**Historical Architectural Review Board
COA Preliminary Review Sheet**

HDC-2026-00009

Address: 1515 Linden Street

Proposal: Remove and replace 5 single doors on the bandshell.

Front left stage door (Applicant)

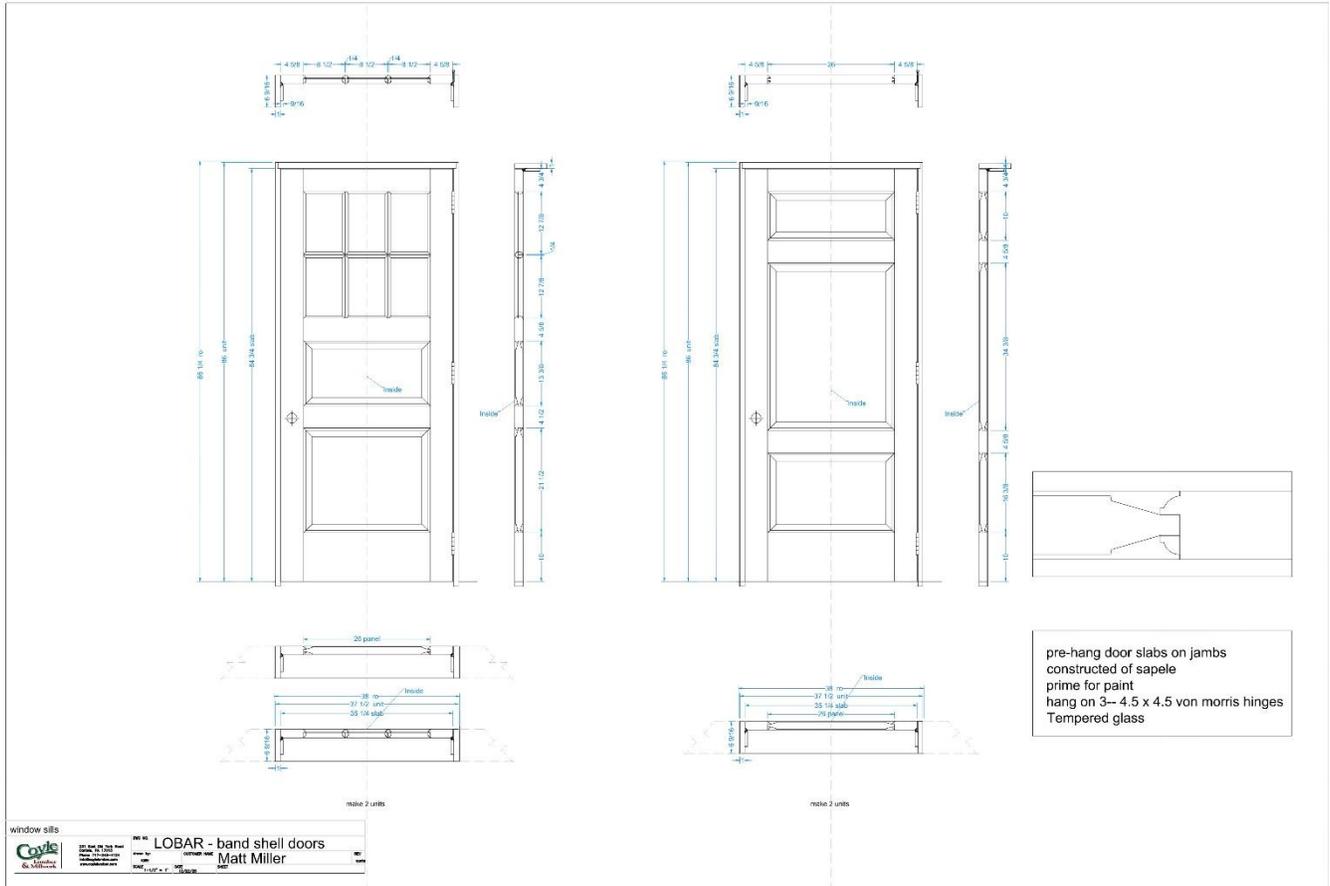
Some of the original doors remain in various states of disrepair. Given the significance of the band shell structure, original materials should be salvaged.

Staff Recommendation: Staff recommend approval with the condition that original doors are salvaged.

Shop Drawings (Applicant)

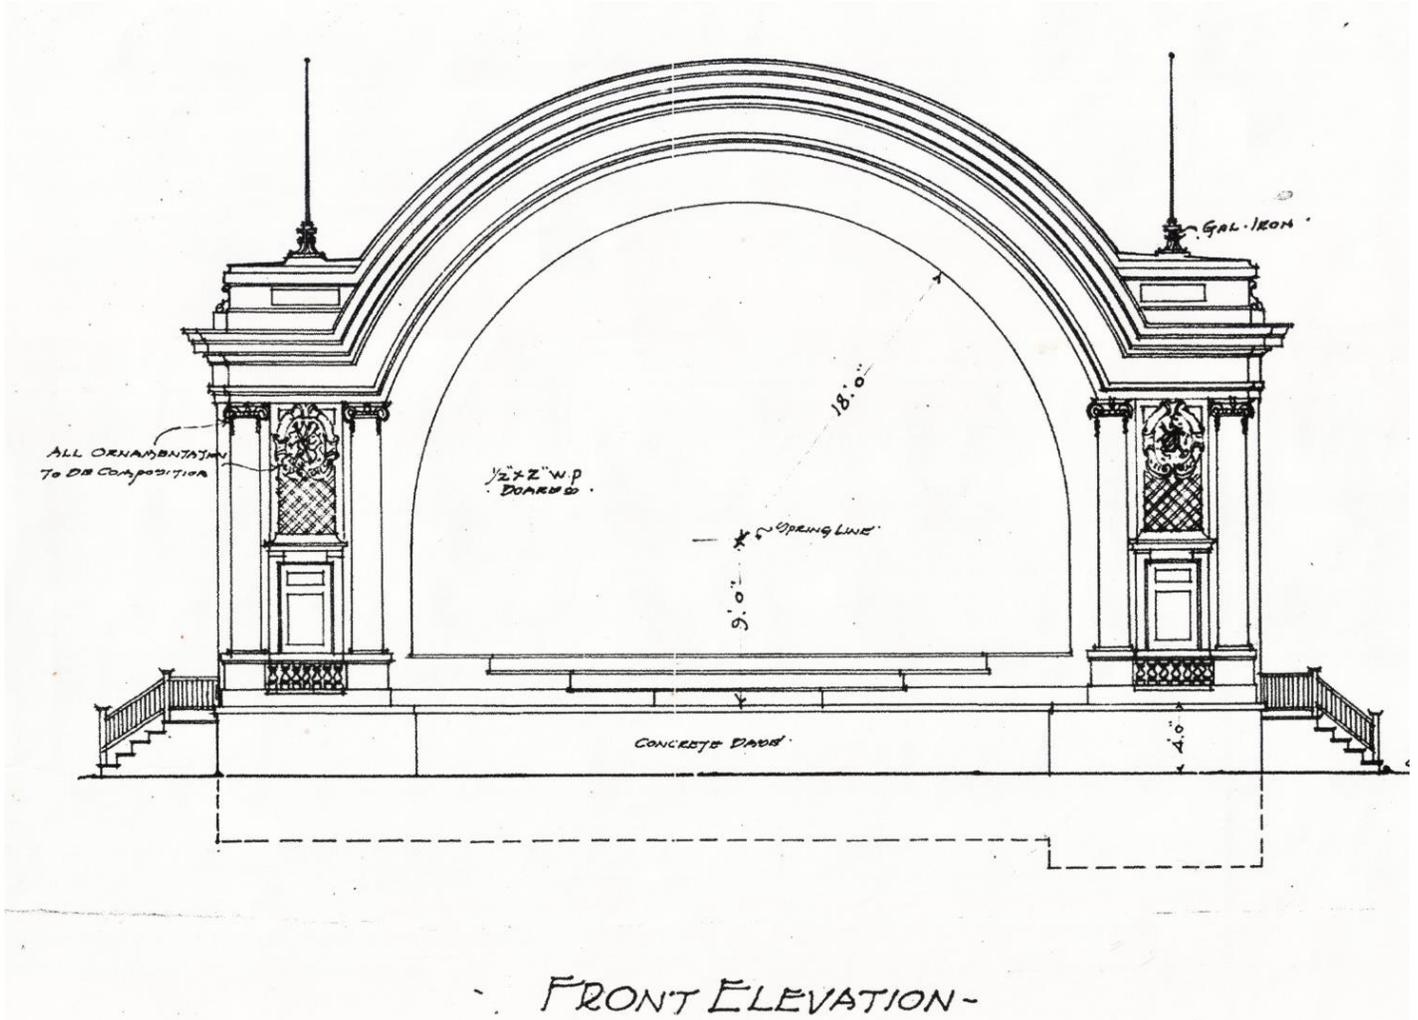
Observations & Comments: The application drawings indicate that the proposed stage doors are constructed of sapele mahogany and are to be painted. The door configuration for the front and side stage-level doors are consistent with the design and configuration of the original doors as seen in existing conditions and original building drawings. The ground floor door is currently a painted plain metal flush door; replacing to match current configuration is appropriate.
